Staff Report

Perry City Planning Commission

Preliminary Subdivision – The Mark at Lake Pointe, Andrew Mecham - located at approximately 2925 S Hwy 89

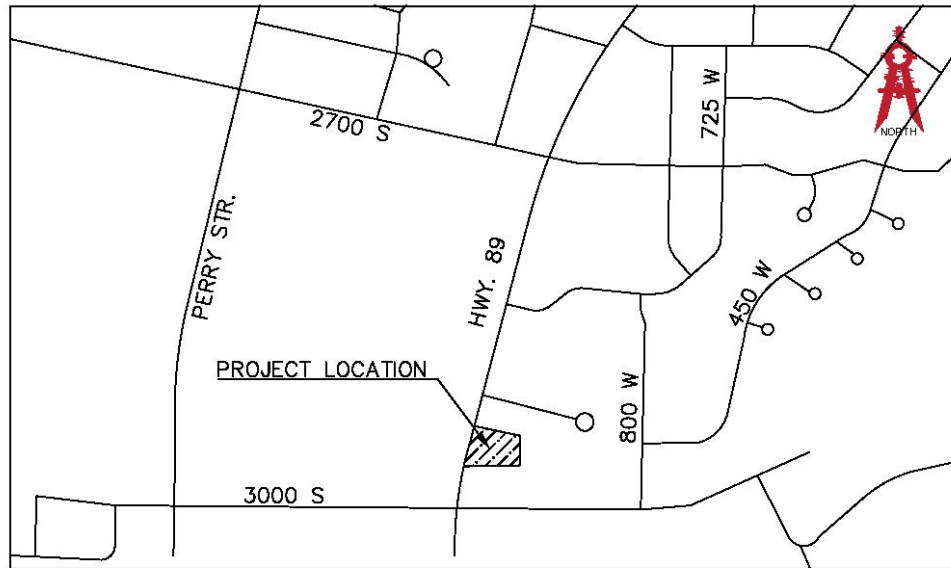
One code issue is that our density map only allows for 18 multi-family units in this area. This proposal exceeds this limit. If the Commission grants approval of this preliminary application it should be for 18 units only with the caveat that if they obtain a code amendment through City Council for the additional unit it may be added in the next application phase.

While complete compliance with our design standards isn't required in the Preliminary Application, it is worth noting a few deficiencies to be addressed. 1 – We require their building to front on the highway with a street presence, direct access, sidewalk, and pedestrian enhancements. In staff's opinion they have done the opposite of this with a landscape buffer between the highway and the units, no direct pedestrian access, and no sidewalk. It should be made clear that these elements will need to be addressed as they move forward with subsequent applications. 2 - The rear of the buildings is required to have not more than 60% be one material. This needs corrected on their plans. 3 – Our code does not allow for repetition of styles. The Commission will need to interpret and apply this code language in the context of this development.
